EPC STORMWATER REVIEW COMMENTS
IN ORANGE BOXES WITH BLACK TEXT

STORMWATER MANAGEMENT PLAN (SWMP)

FOR
FLYING HORSE NORTH FILING NO. 4
SE OF SANDBAGGER DR & OLD STAGECOACH RD
UNINCORPORATED EL PASO COUNTY, CO 80908

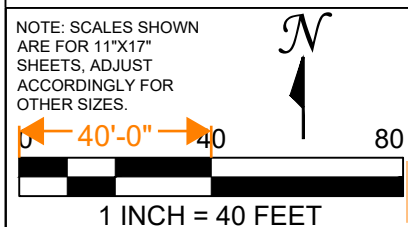
Flying Horse Filings 4 and 5 have lot imperviousness restrictions because the developer chose to utilize the Large Lot Exclusion for water quality which restricts lot imperviousness to 10% or between 10-20% imperviousness with an additional study. Many of these site plans are reporting impervious cover greater than 10% which would trigger the study requirement. I have comments on the reported square footage so please with the next submittal verify all impervious percentages reported. If lots have between 10-20% imperviousness an additional study will be required. Lots cannot be greater than 20% impervious without providing water quality.

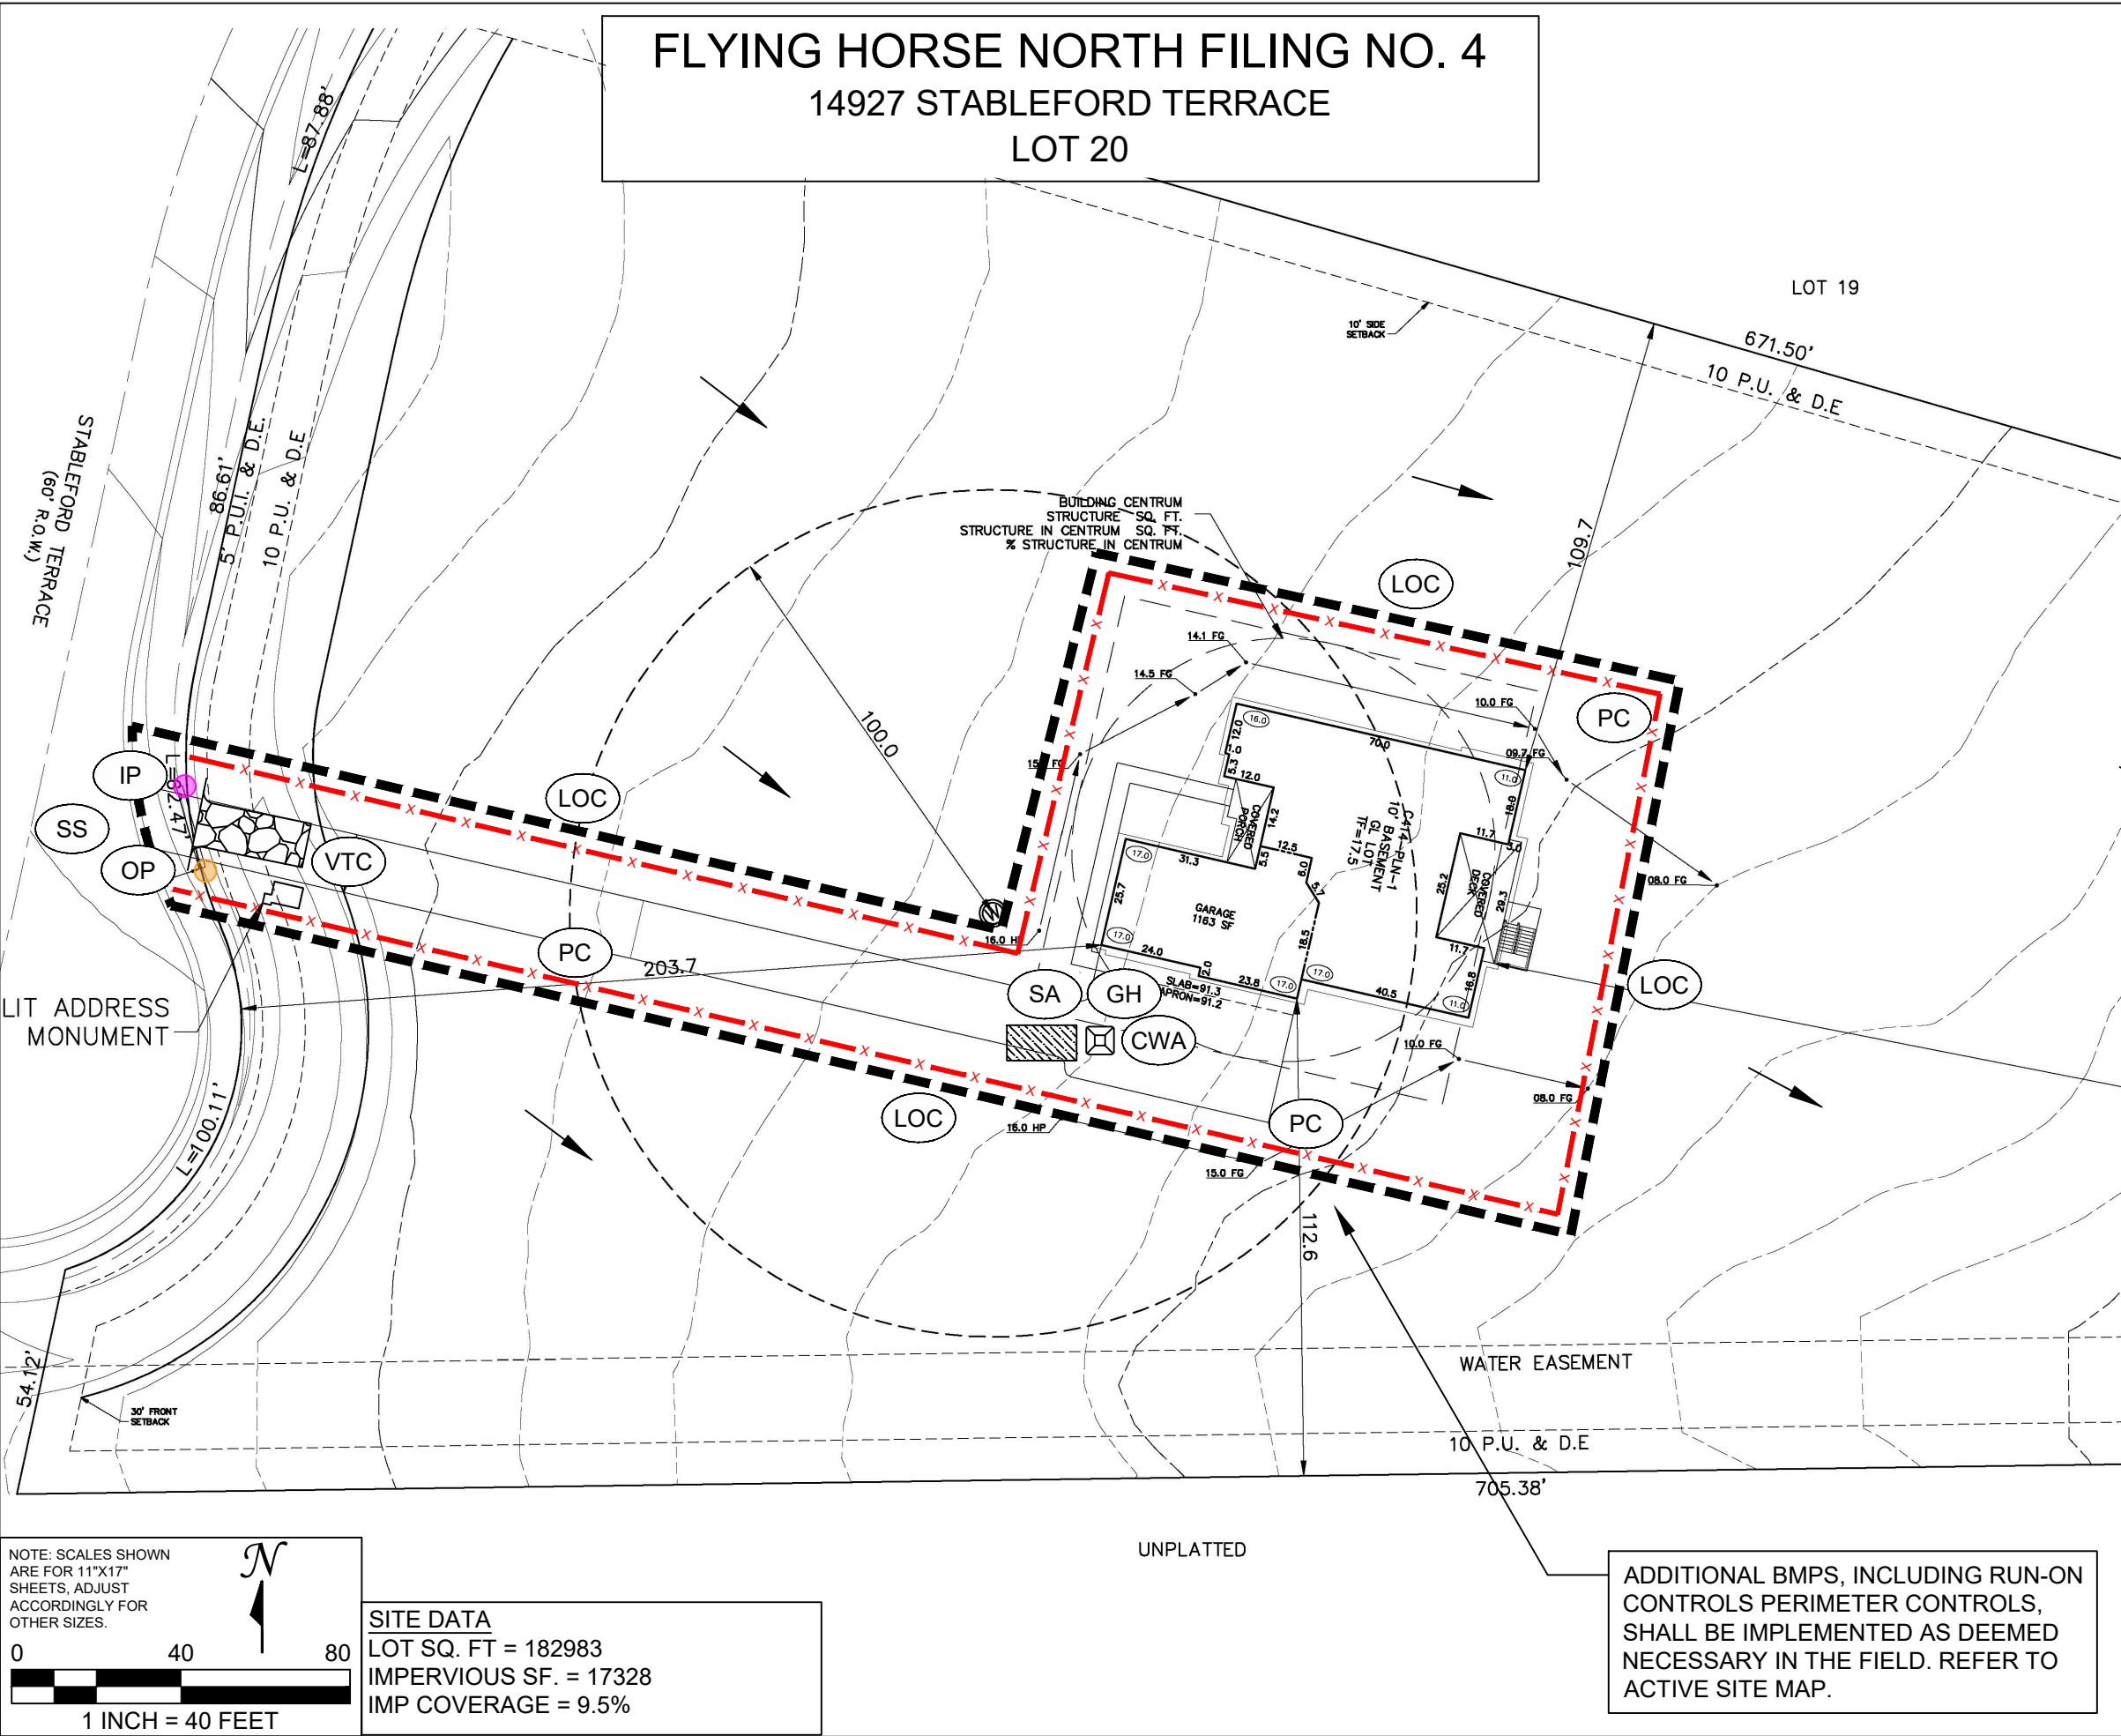
I'm measuring closer to 9 which would be approximately imperviousness. Verify.

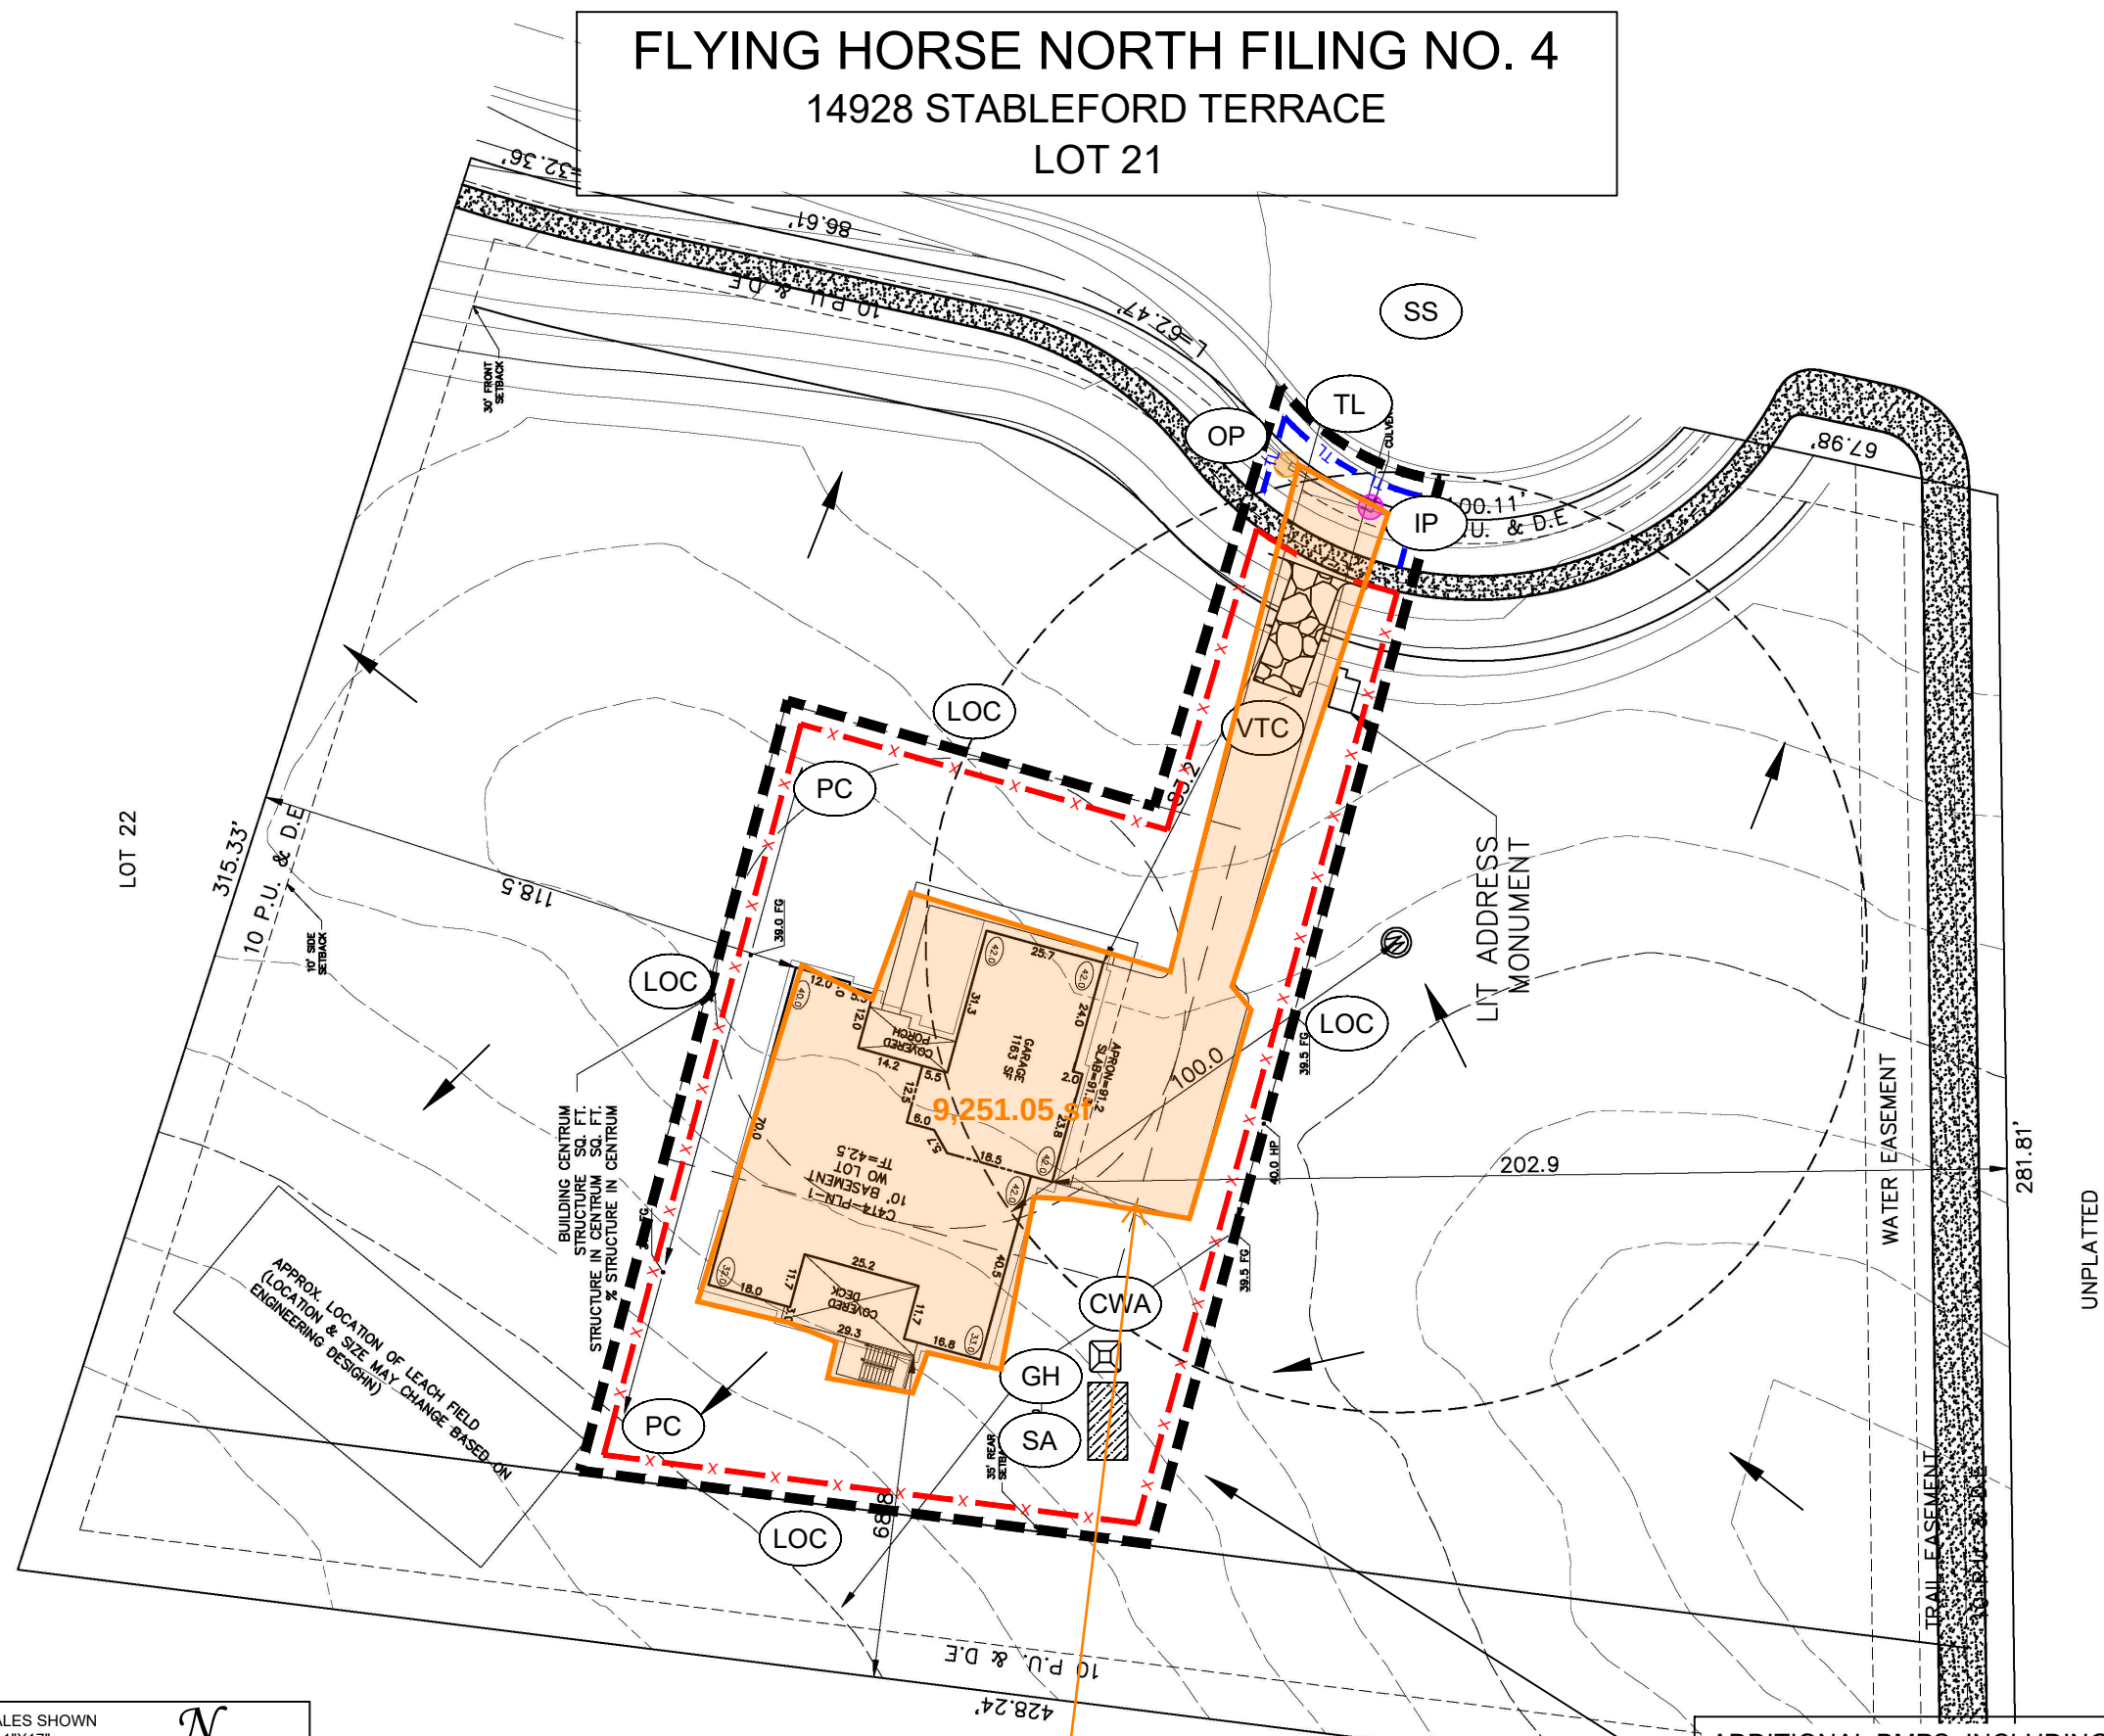
I'm measuring closer to 9,500 sqft which would be approximately 9% imperviousness. Verify.

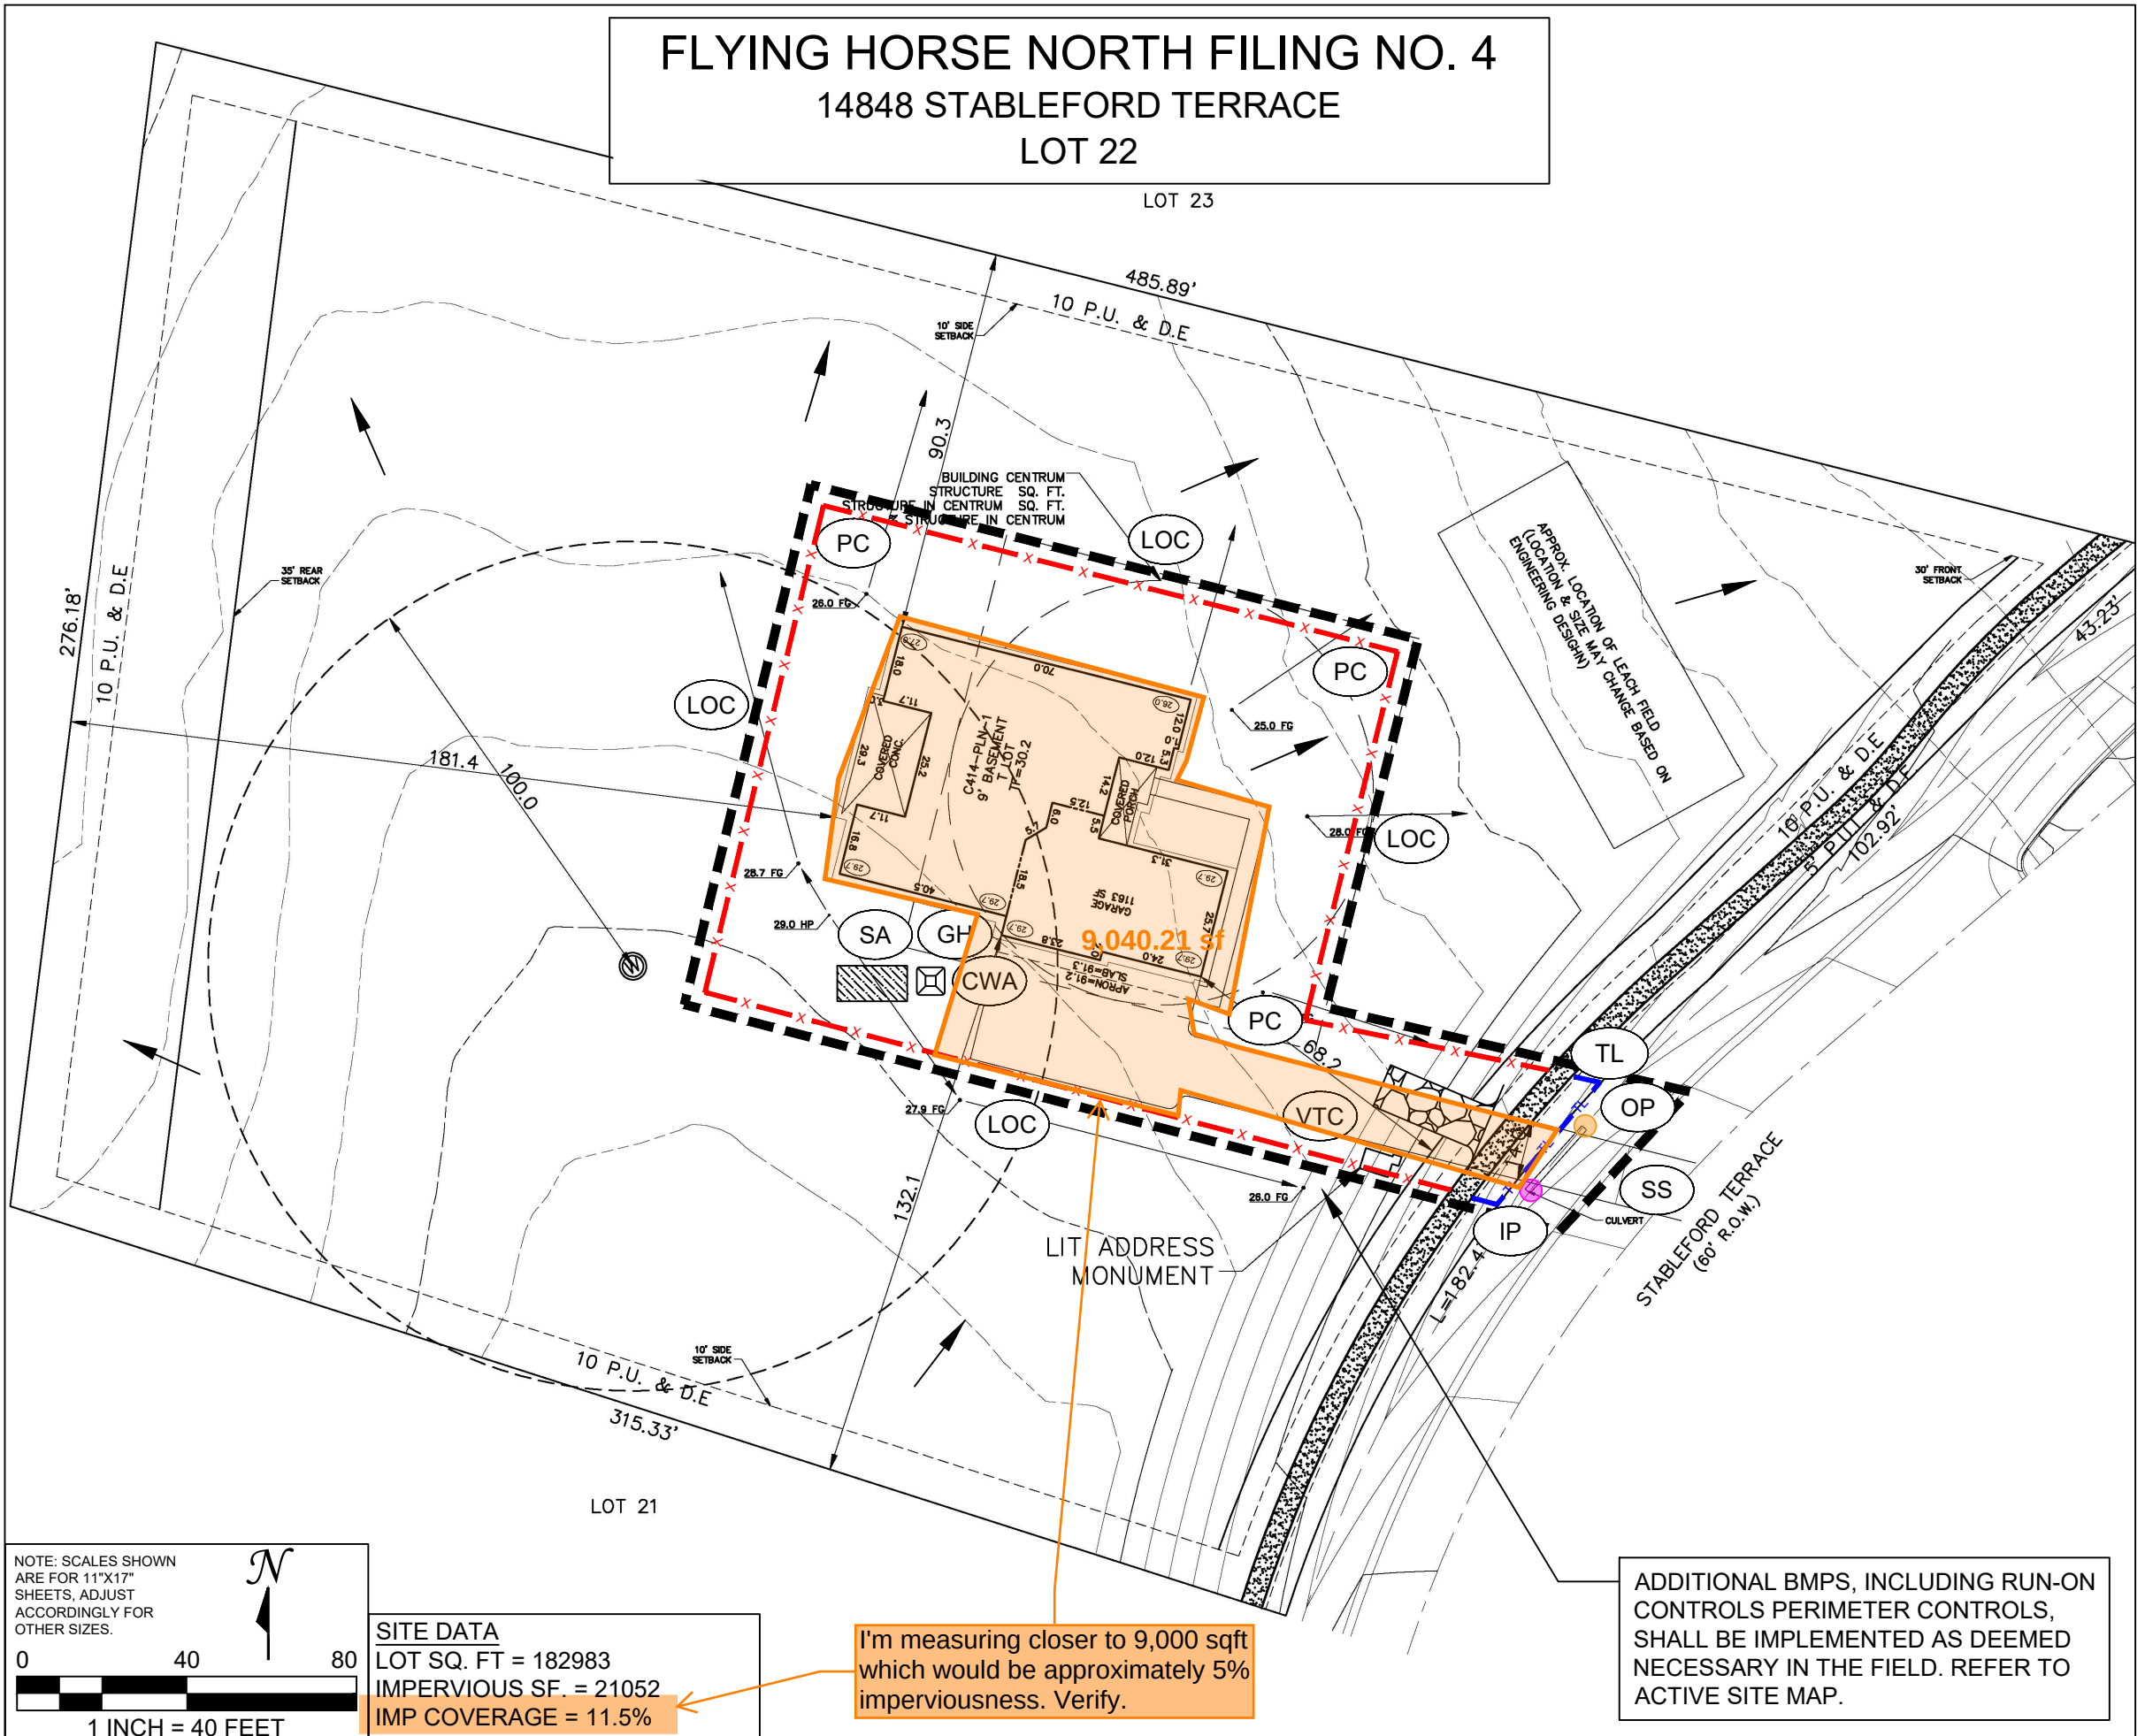
I'm measuring closer to 9 which would be approximately imperviousness. Verify.
